DESIGN 	DRAWN BY RT	DART AEROSPACE LTD HAWKESBURY, ONTARIO, CANADA	
CHECKED 	APPROVED 	DRAWING NO. DSI 9225	REV. A SHEET 1 OF 1
DATE 01.12.13		TITLE D500-572-013 ON LOW GEAR	SCALE NTS
A	01.12.13	NEW ISSUE

DART SERVICE INSTRUCTION

TO AMEND IIN-D500-572 REV. A

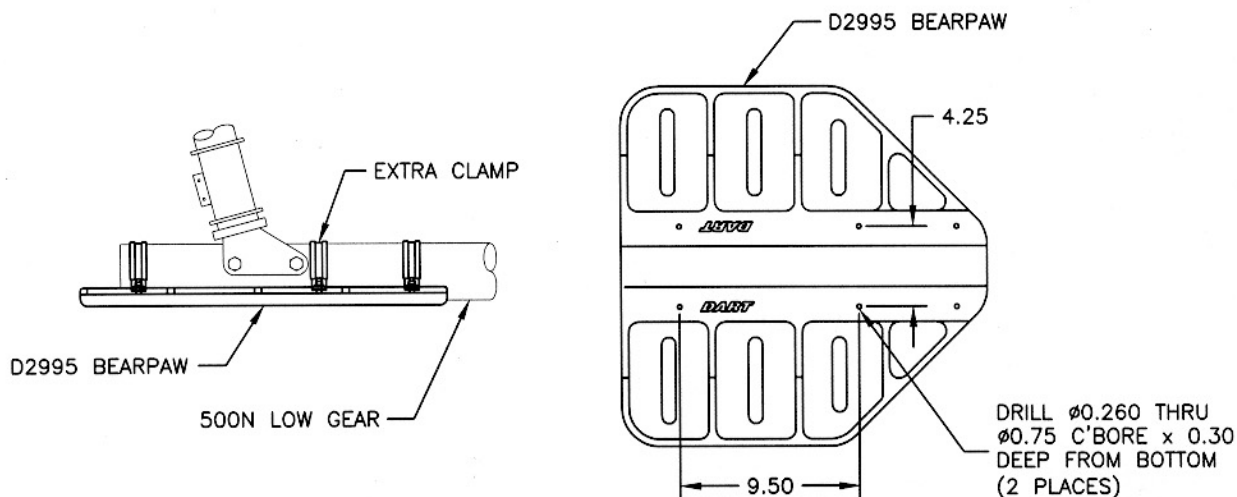
TO FACILITATE INSTALLATION OF THE D500-572-013 BEARPAW KIT ON THE 500N ON LOW GEAR, THE KIT SHOULD BE MOVED FORWARD AND AN EXTRA CLAMP SHOULD BE INSTALLED AS DIAGRAMMED BELOW.
